Final Environmental Impact Report  
for the Crystal View Terrace/Green Orchard Place/  
Overlook Parkway Project  
(P11-0050 – EIR & P12-0220 – GP)  
City of Riverside  
SCH No. 2011021028

City of Riverside  
Community Development Department  
Planning Division  
3900 Main Street, Third Floor  
Riverside, CA 92522

RECON Environmental, Inc.  
1927 Fifth Avenue  
San Diego, CA 92101-2358  
P 619.308.9333 F 619.308.9334  
RECON Number 6103  
November 2015

**FIGURE R-1**  
Neighborhood Traffic Management Program

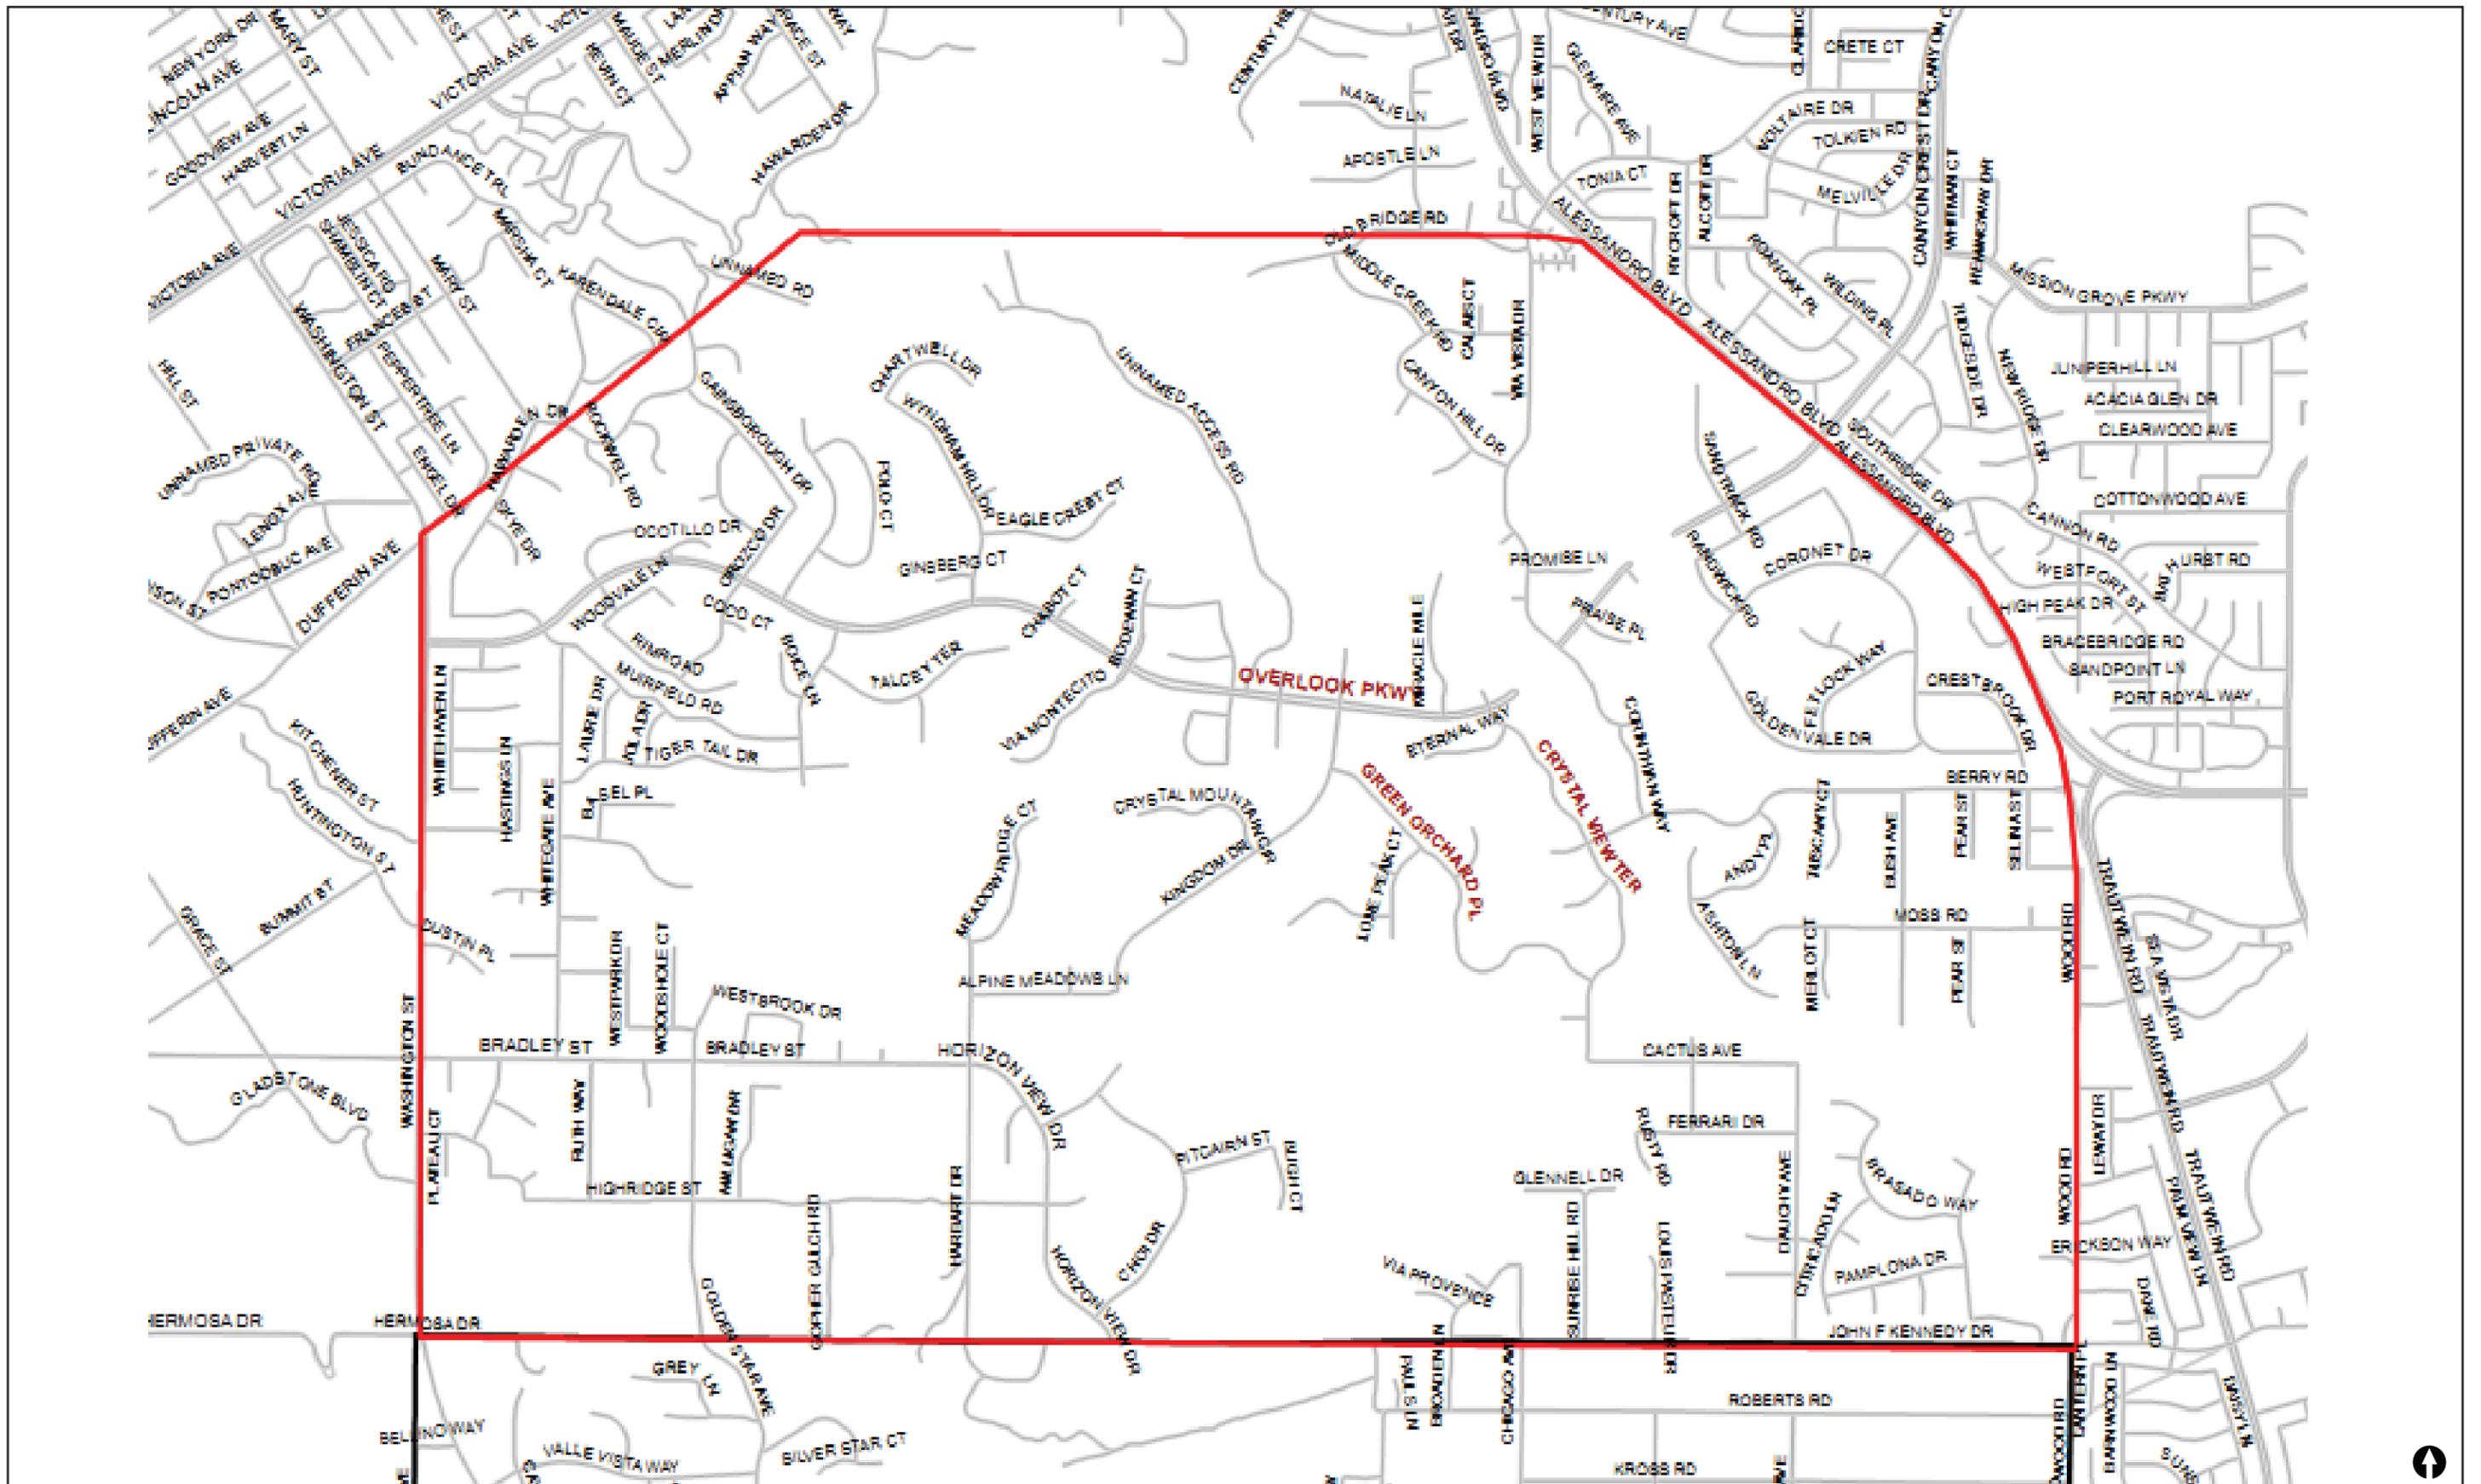
Should further analysis show the solution is not effective in resolving neighborhood traffic concerns, an additional traffic calming tool from the *Initial* or *Secondary Options* may be considered. Factors such as road width, alignment, and configuration may prevent the use of *Secondary Solutions*. Additionally, some of the solutions within this category may require consensus by a majority of neighborhood residents.
